500mm Manlid Cover Design Update: July 2025

Figure 2
 Manlid cover lug bracket after July 2025, with the special retaining bracket

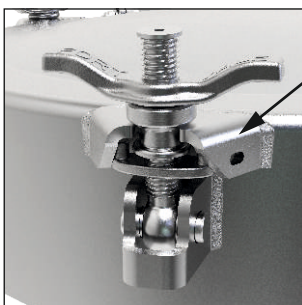
From July 2025, the design of our 500mm manlid covers changed. The new geometry of the manlid cover lug brackets means that a special retaining bracket is welded to the cover lug bracket where a safebolt is installed. Refer to Figure 2. If you order a new manlid assembly with a safebolt, Fort Vale welds the special bracket.

If you want to change a standard fastener to replace it with a safebolt assembly on a manlid made after July 2025, a conversion kit is necessary, part no. 701/KIT. You must weld the special retaining bracket to the cover lug bracket. This procedure is shown in the Installation and Operating Instructions, ref. **OPIN100**.
